## ADDENDUM NO. 1

TO: **PLANS AND SPECIFICATIONS FOR STATE OF MISSOURI**

**Troop A Headquarters, MSHP  
Lee's Summit, Missouri  
PROJECT NO. R2219-01**

### 1 ROOF FRAMING PLAN - FIRING RANGE (ALTERNATE #04)

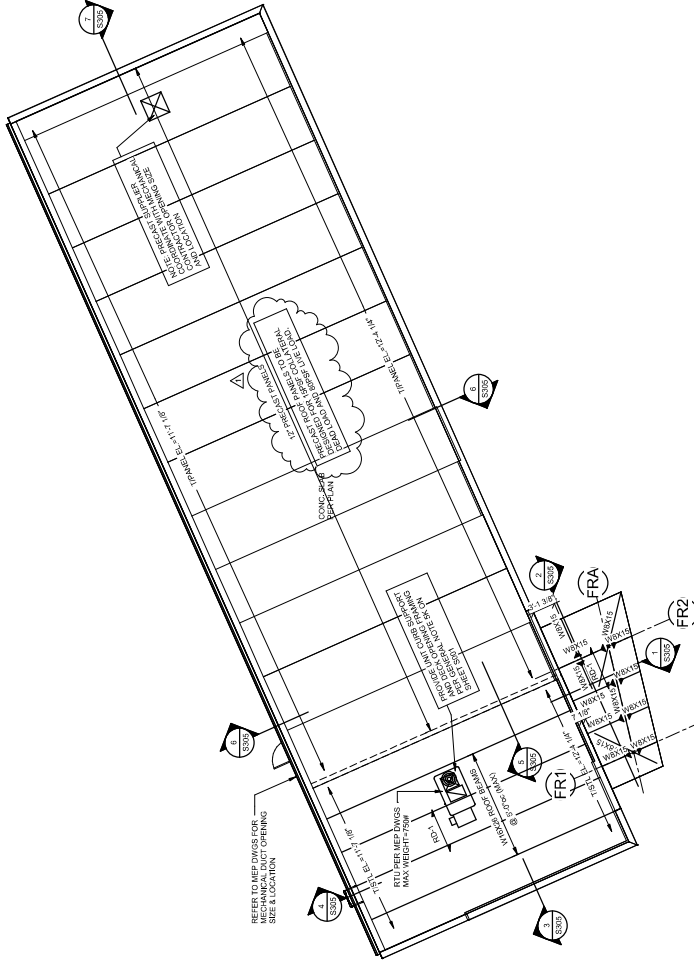
1. Sheet S113:
  - a. MODIFY (Attached): Precast roof panel note to remove the reinforcement restriction
2. Sheet A-601 (Attached) :
  - a. ADD: Comment '1' to Door 145B.

**Frame Types**

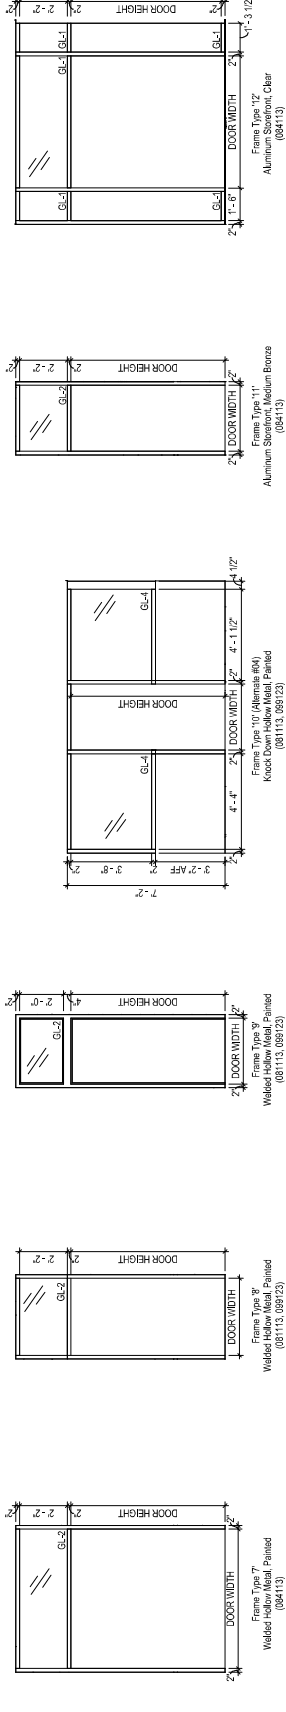
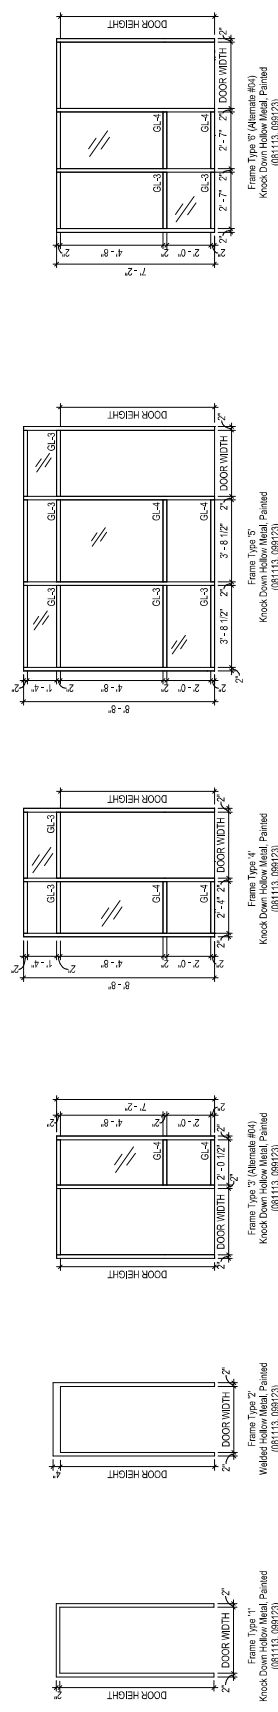
3. Sheet A-602 (Attached):
  - a. MODIFY: Frame Type 14 from Hollow Metal to Aluminum.
4. Sheet M602 (Attached):
  - a. Changed electrical motor phase data for HWCP-1 and HWCP-2 from 1 phase to 3 phase.

1 FLOOR PLAN - POWER - WEST  
1/8" = 1' 0"  
6' 3" 4" 10"

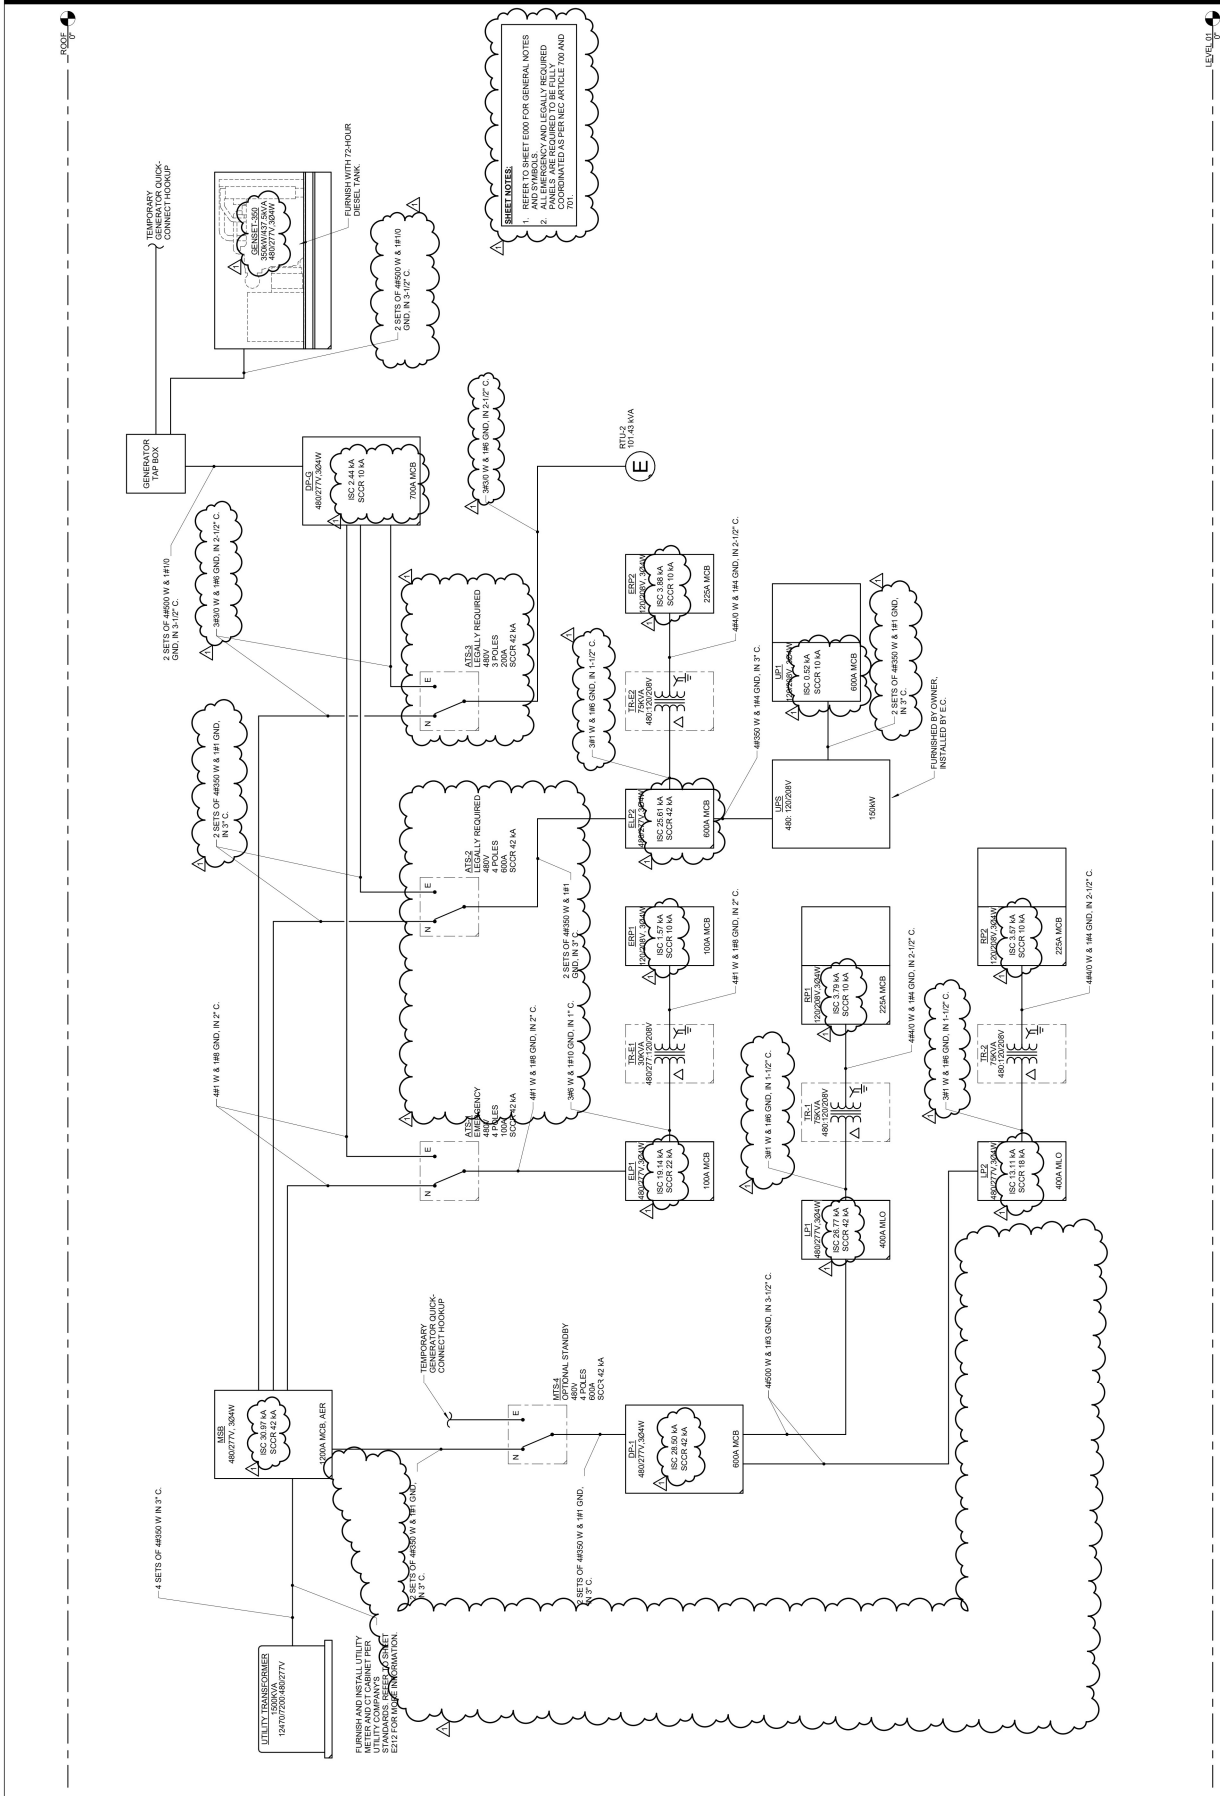
5. Sheet E212 (Attached) :
  - a. Changed circuit numbers for HWCP-1 and HWCP-2 to match pumps changing from 208V, 1 phase to 208V, 3 phase.
  - b. Adjusted size of generator tap box from 600A to 700A.

- c. Adjusted size of DP-G from 600A to 700A.
  - d. Changed generator size from 275kW to 350kW.
6. Sheet E500 (Attached):
  - a. Added estimated short circuit current values for all panels.
